From: Ashley Helme Associates <aha@ashleyhelme.co.uk>
Sent: 04 January 2016 11:17
To: 'White, Joy - E&E'; 'Payne, Odele - Environment & Economy'
Cc: Andy Green
Subject: 1361: White Post Road, Banbury
Attachments: White Post Road, Bodicote, Banbury RSA1, Rev A.pdf; 1361-22-B.pdf

White Post Road, Bodicote, Banbury

Road Safety Audit Stage 1

TMS reference no: 12522A

Appendix B

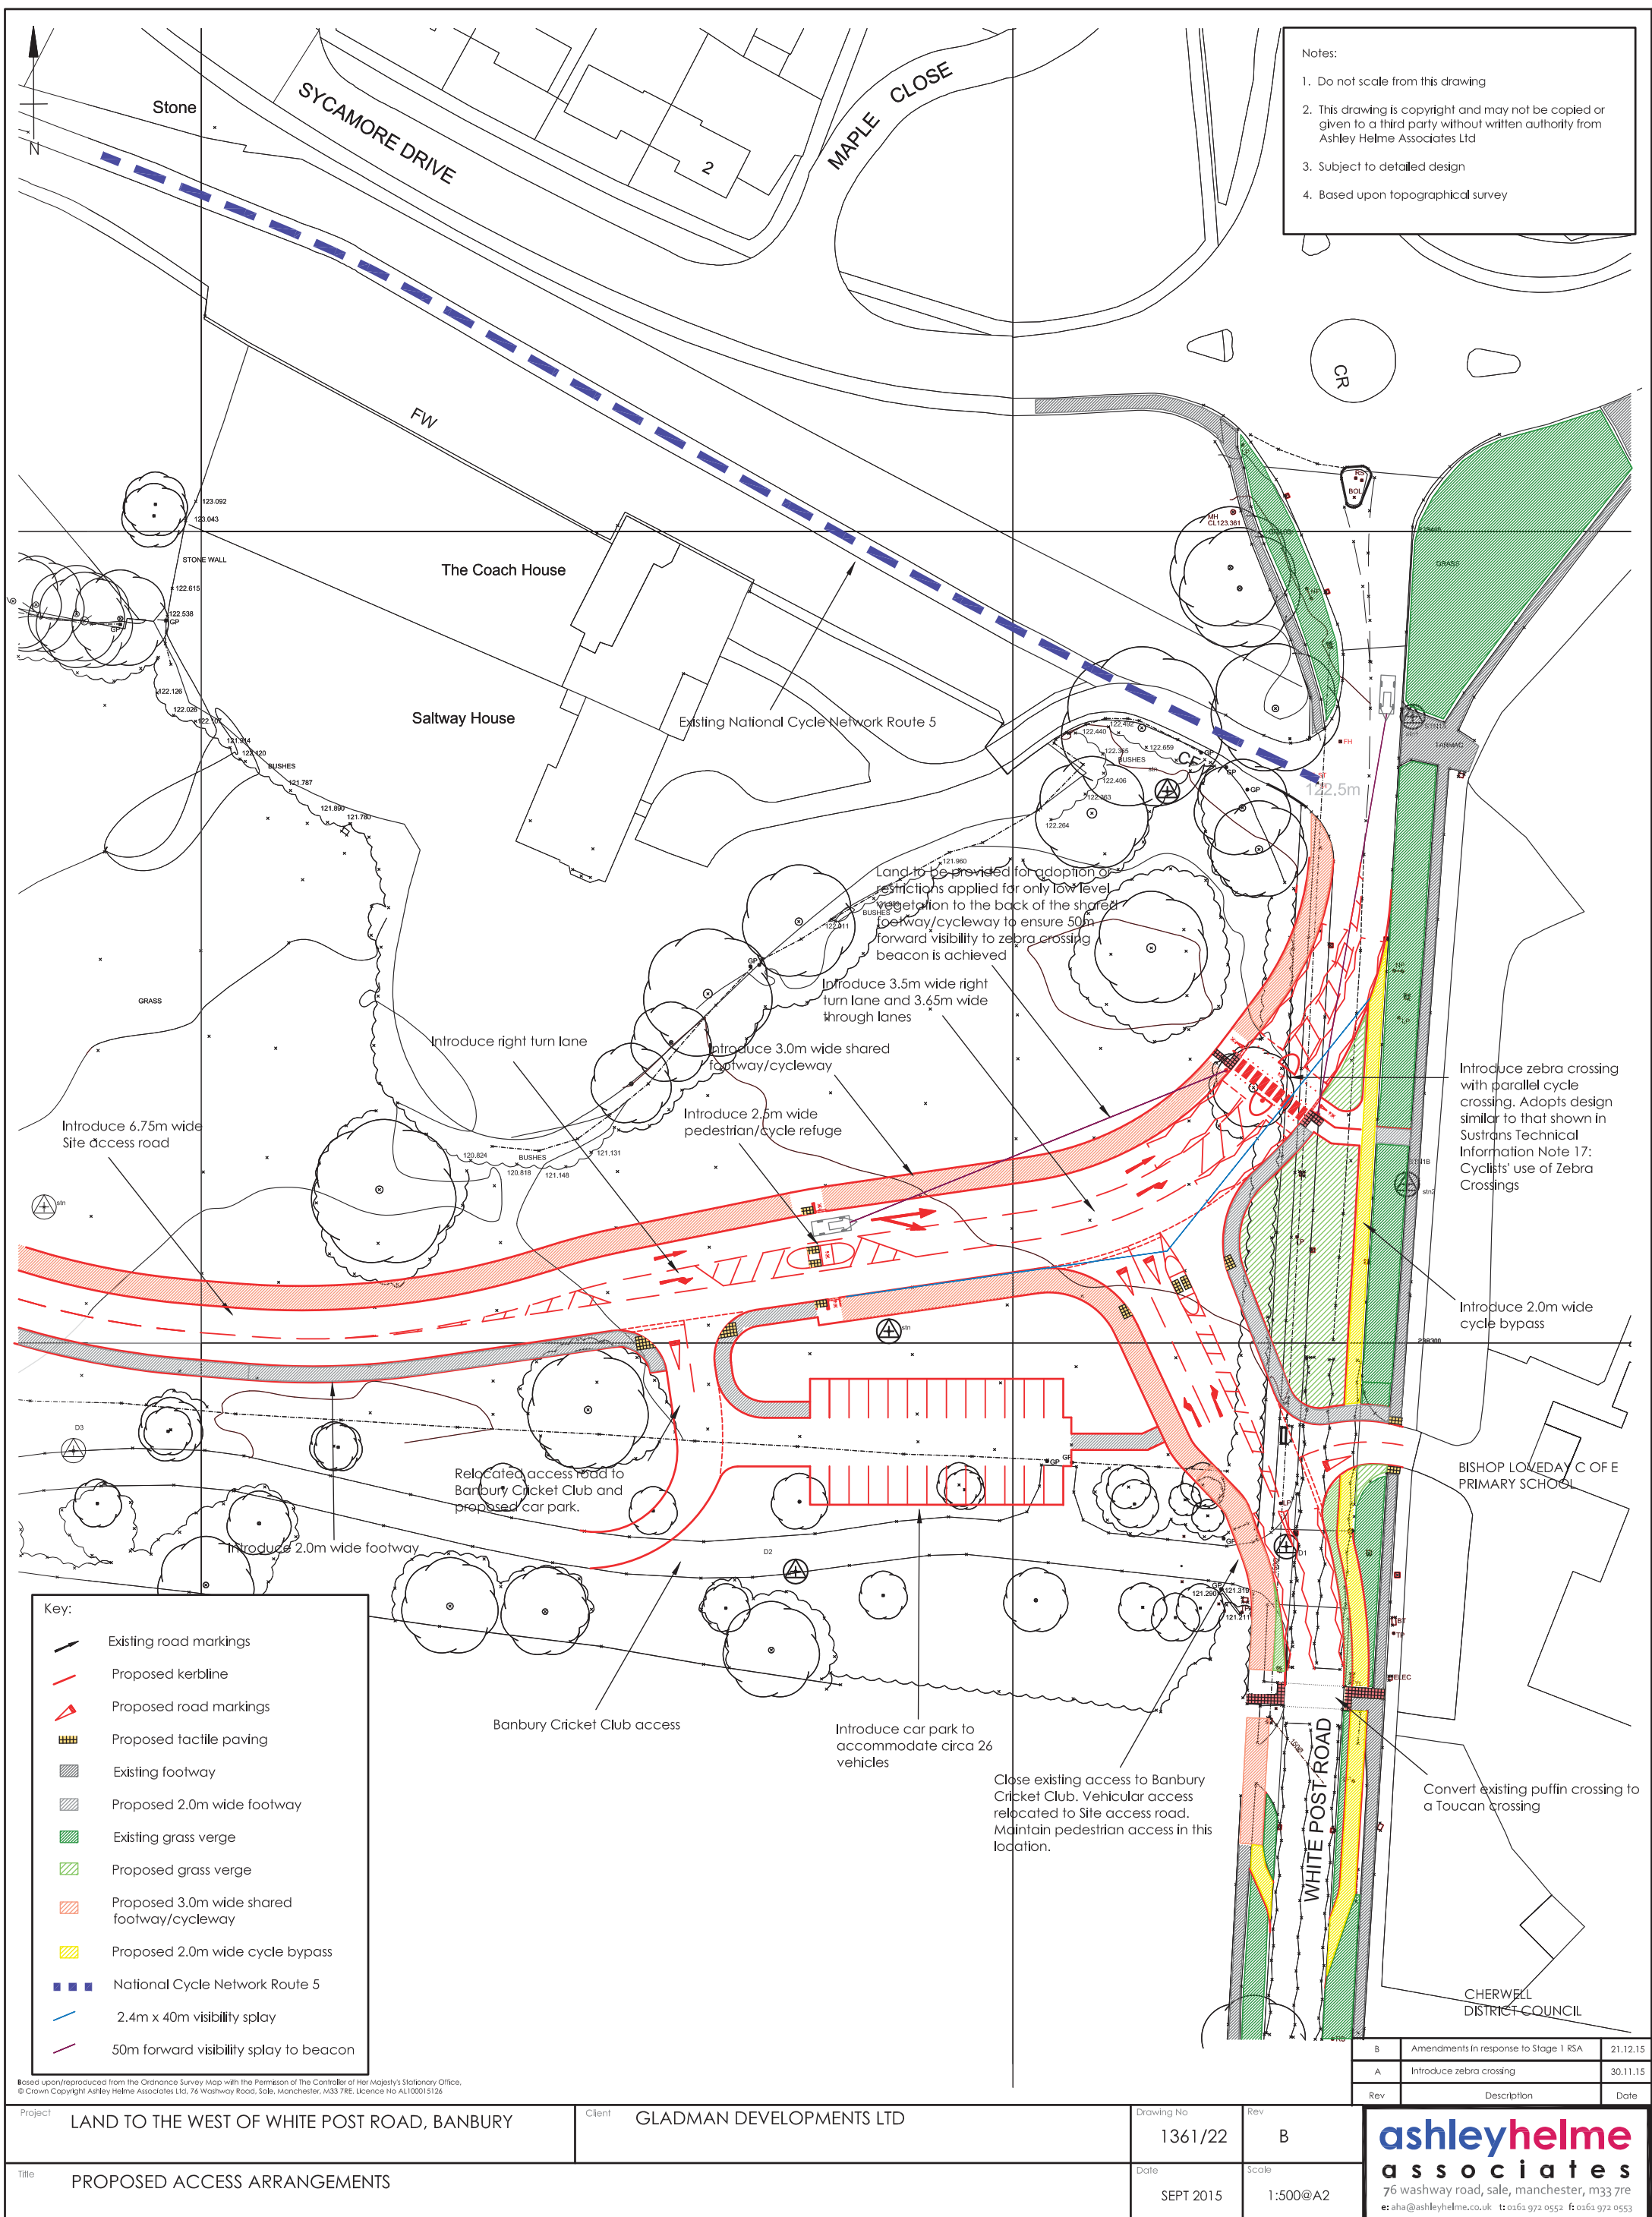
2.1 PROBLEM

Location – General – On street parking

Summary: Increased risk of collisions due to restricted visibility

At the time of the site visit, there were numerous parked vehicles along both sides of White Post Road. The proposed car park of 26 spaces may not be enough to accommodate the existing on-street parking demand. Vehicles parked inappropriately could reduce visibility around the scheme at junctions and crossing points, thereby increasing the risk of collisions.

2.2 PROBLEM

Location – White Post Road

Summary: Risk of loss of control collisions

Road users travelling along both directions of White Post Road may see-through to the old straight ahead road alignment, particularly if existing hedgerows and street lighting remain at current locations. This could increase the risk of vehicles losing control, particularly in times of reduced visibility.

2.3 PROBLEM

Location – Existing Puffin crossing

Summary: Increased risk of collisions involving cyclists

The proposed shared footway/cycleway starts to the north of the existing puffin crossing on the west side of White Post Road and the cycle bypass terminates to the north of the puffin crossing on the east side of White Post Road. Cyclists travelling northbound along White Post Road will not have facilities to allow them to cross to the east side cycle bypass which could increase the risk of collisions involving cyclists.

2.4 PROBLEM

Location – Southern end of cycle bypass

Summary: Risk of cyclist collisions

The southern end of the cycle bypass joins White Post Road on a radius curve with a forced merge. This could increase the risk of collisions with other road users.

2.5 PROBLEM

Location – Cricket Club right turn lane

Summary: Risk of shunt and side swipe collisions

The width of the proposed right turn lane for the cricket club varies end to end. Vehicles entering the right turn lane may unexpectedly overhang into the ahead lane in either direction. This could lead to shunt or side swipe type collisions occurring.

RECOMMENDATION

The need for additional off-street parking should be established. Parking within the visibility splays of junctions and crossings should be prohibited within the detailed design.

RECOMMENDATION

At detail design, measures should be provided to reduce the effect of any see through of the old road alignment.

RECOMMENDATION

The cycle bypass and shared footway cycleway should be extended to the south side of the puffin crossing which should also be upgraded to a Toucan crossing or a zebra crossing with a parallel cycle crossing.

RECOMMENDATION

The cycle bypass should be extended to the southern side of the puffin crossing (see problem 2.3) with a parallel kerbed separation build-out provided to protect cyclists entering the carriageway from other road users.

RECOMMENDATION

A consistent width right turn lane should be provided for the cricket club.
